SOUTHWEST BIKEPATH CULVERT REPLACEMENT AT WAITE CIRCLE - 2019

CITY OF MADISON, WI

CITY PROJECT NO. 8466

ADDENDUM 1
8/29/19
CHANGED ENTIRE
DRAWING

DRAWING NUMBER
C-5
 SHEET NUMBER
 10 OF 25

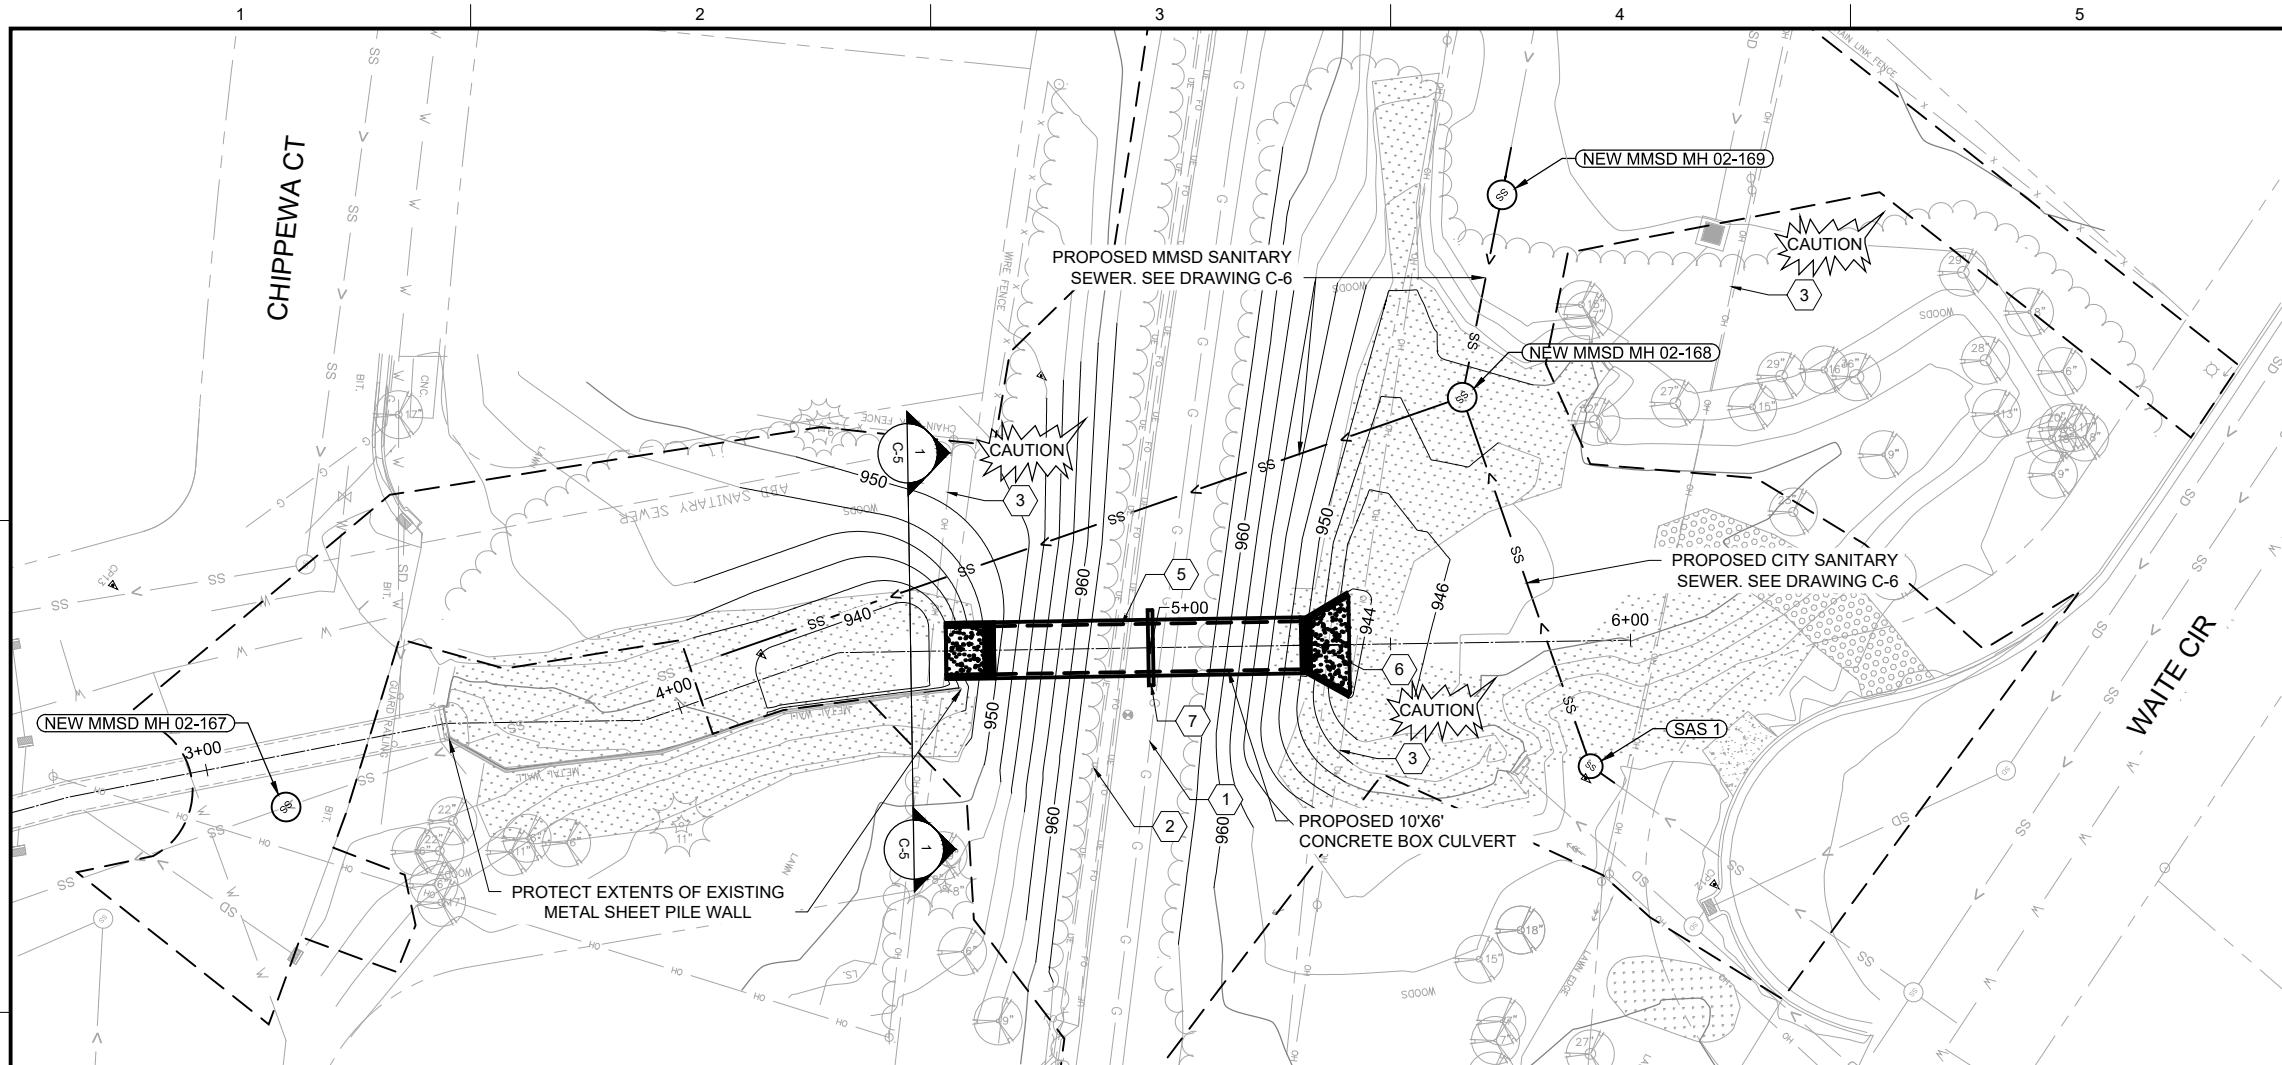
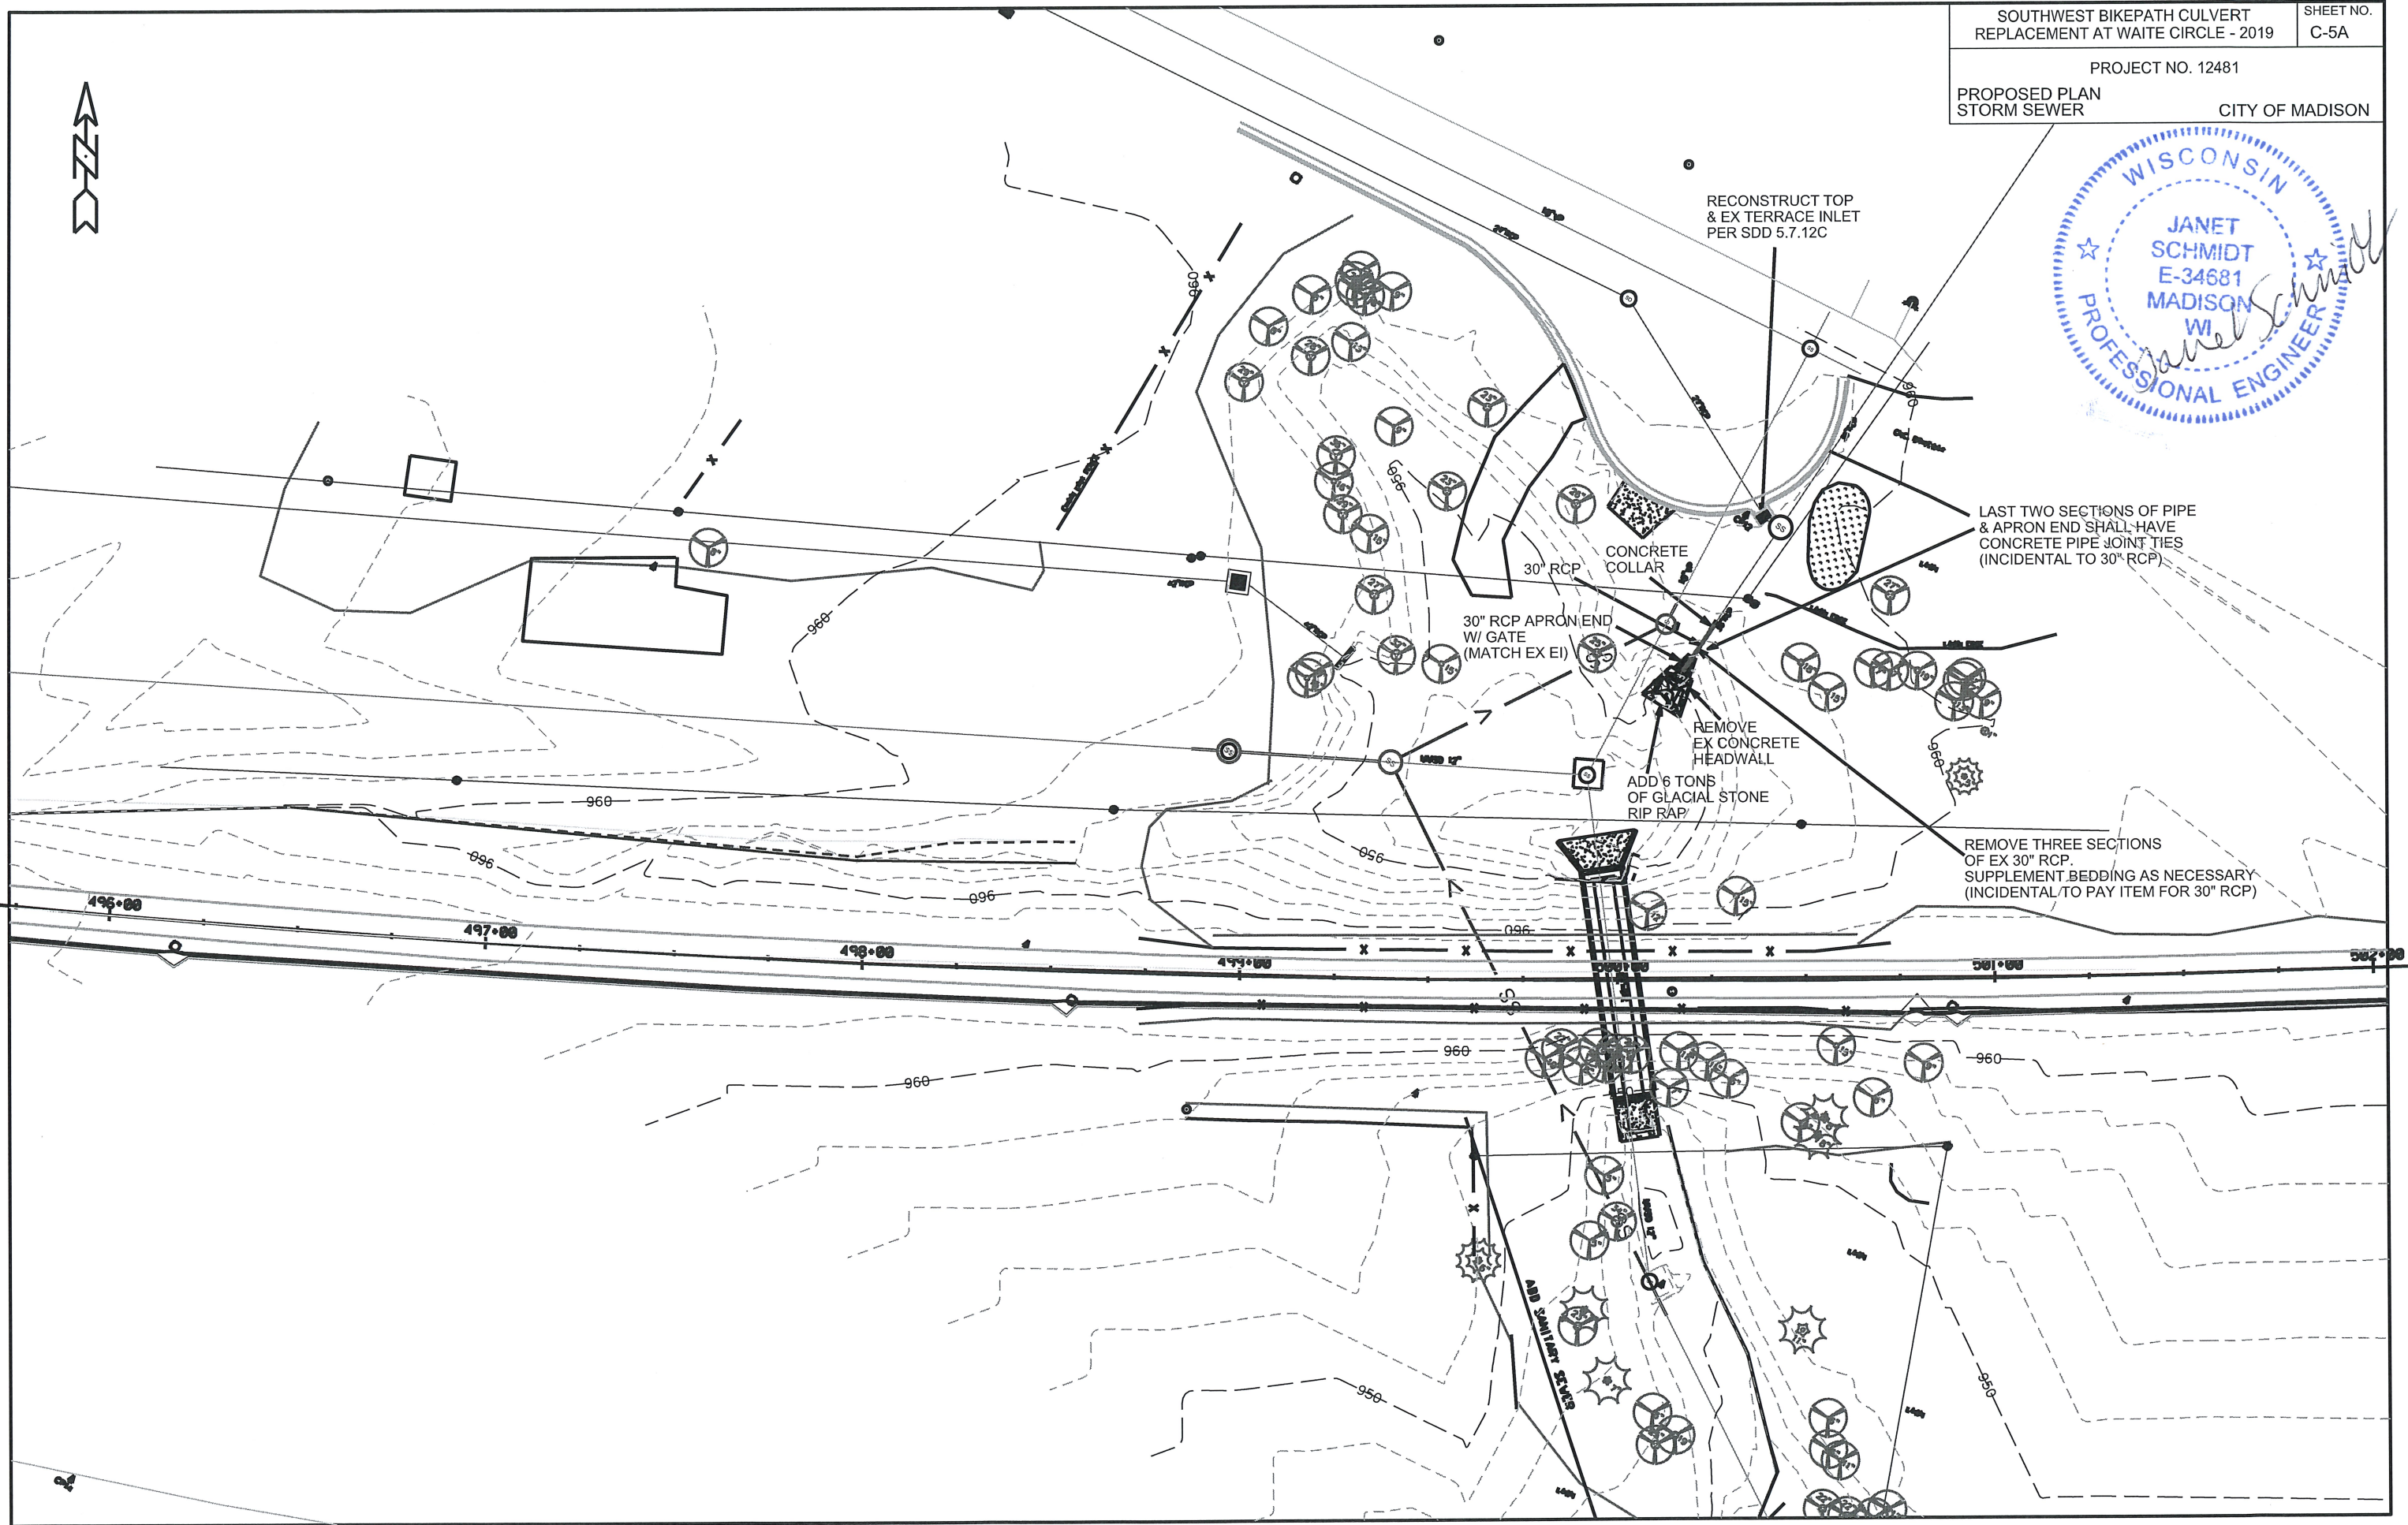
**ADDENDUM 1
CHANGED
ENTIRE
DRAWING**

DRAWING NUMBER
C-6
 SHEET NUMBER
 12 OF 25

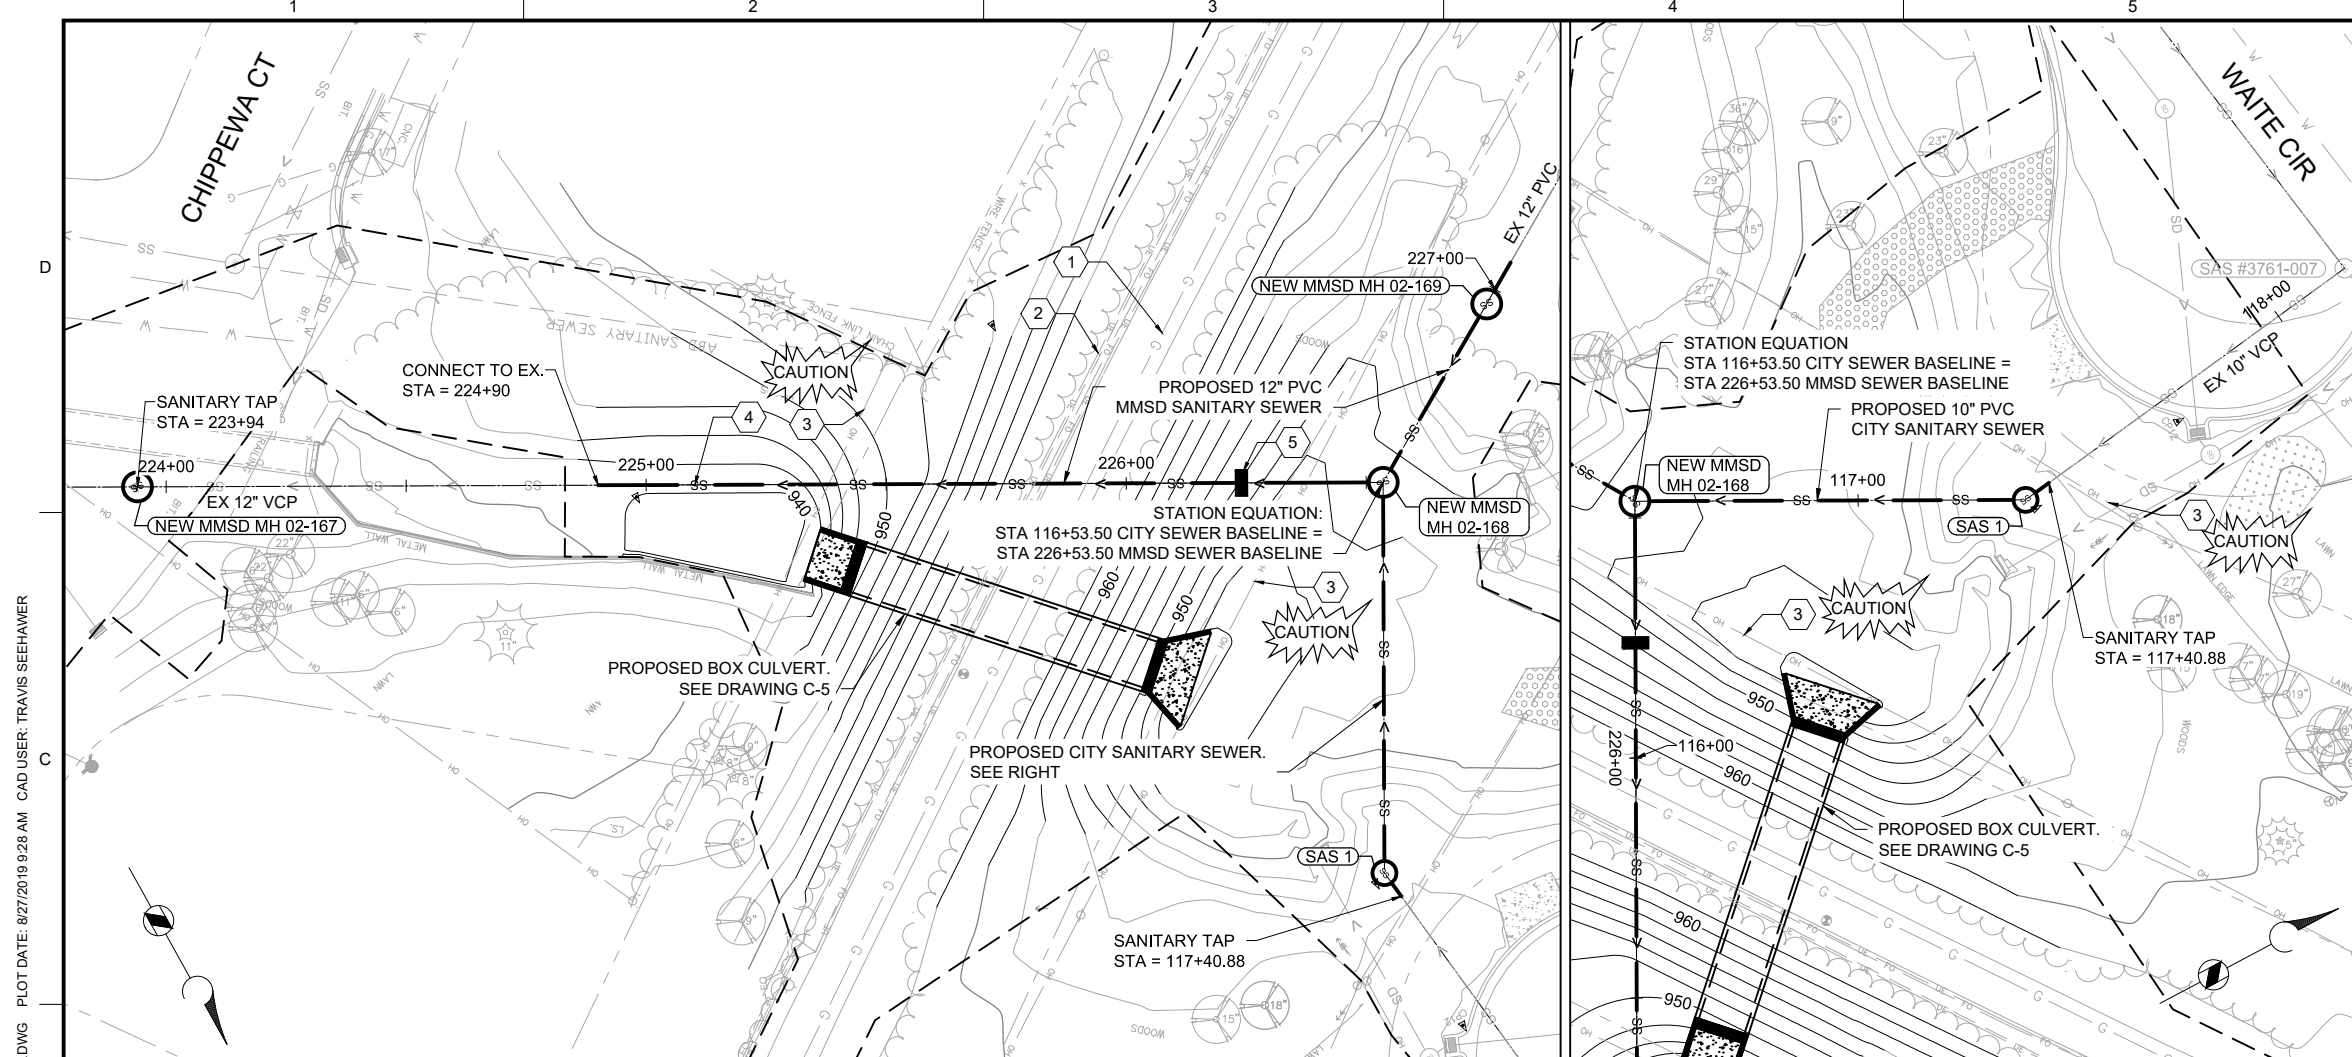
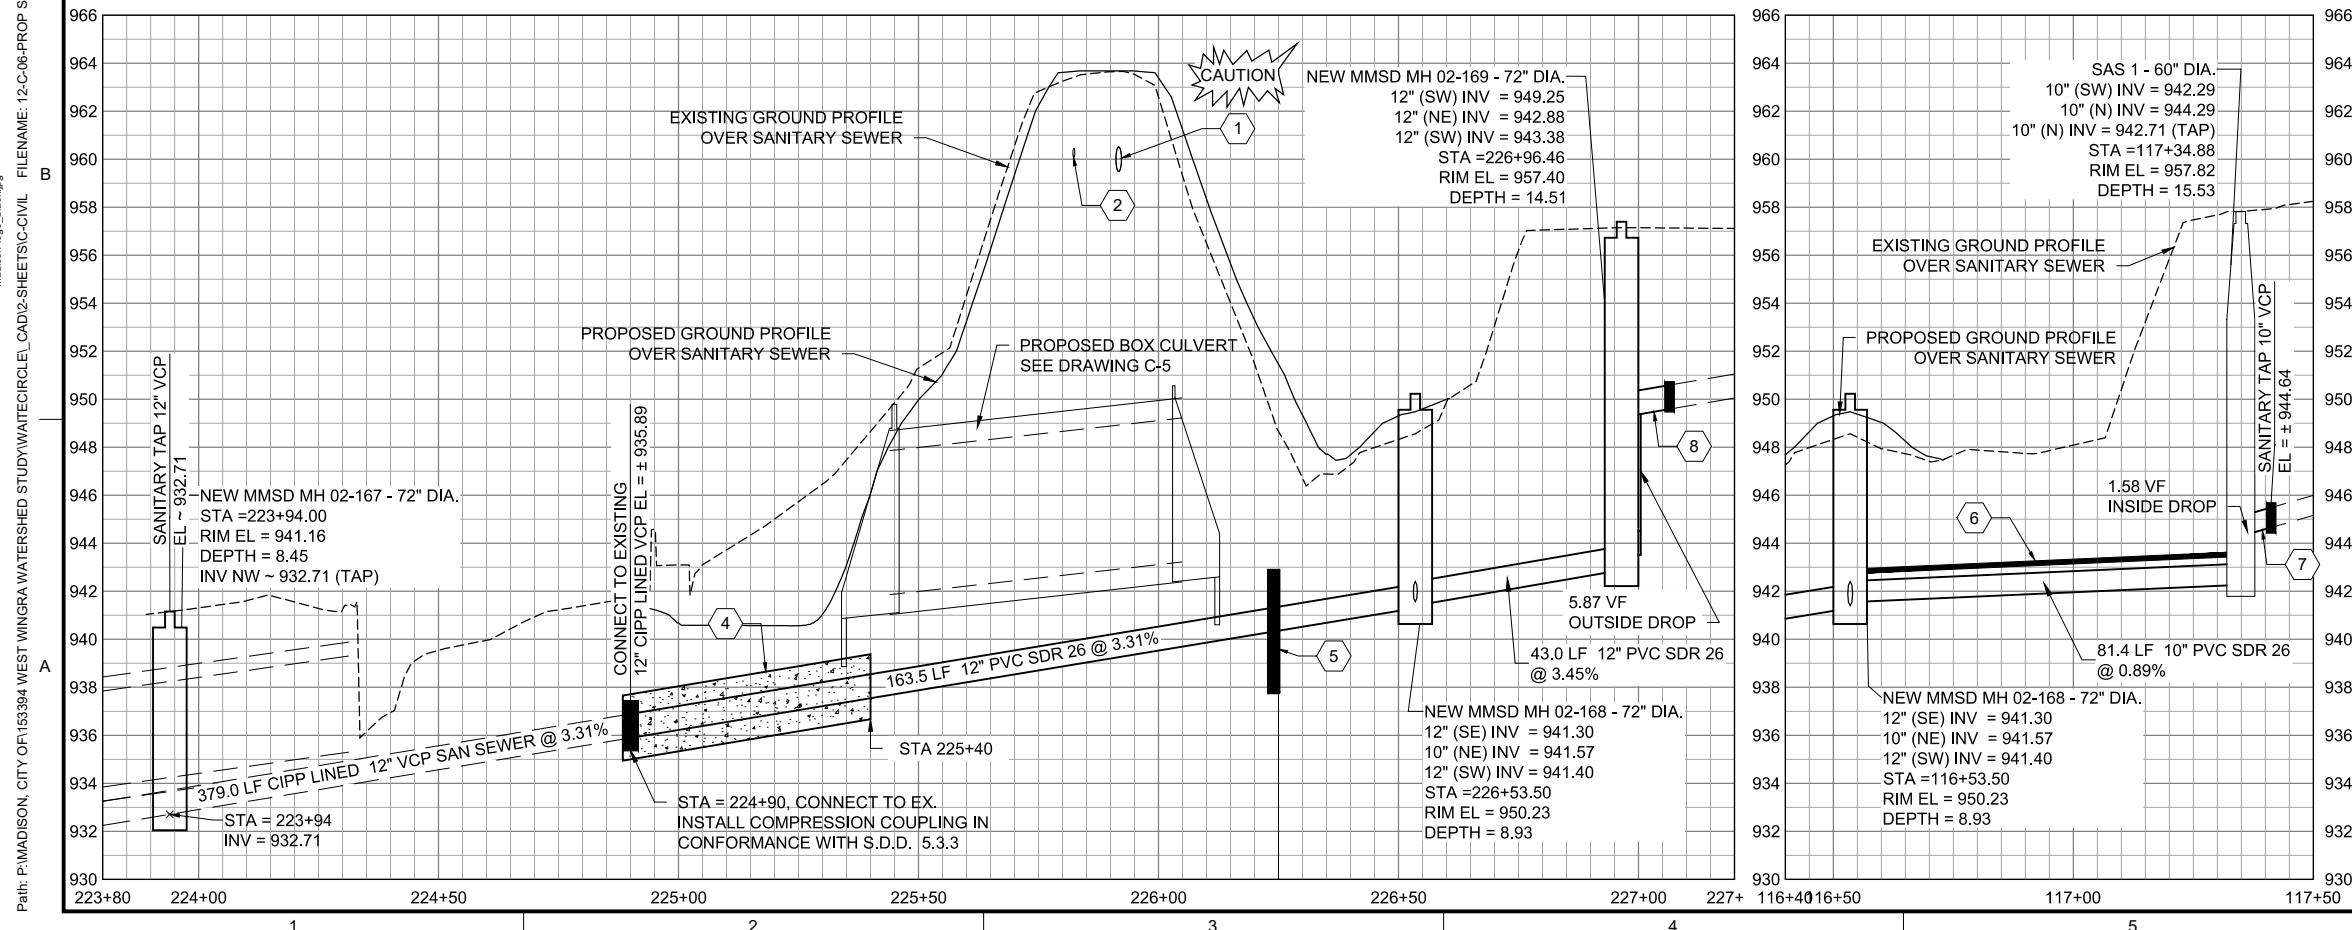
**ADDENDUM 1
 CHANGED
 ENTIRE
 DRAWING**
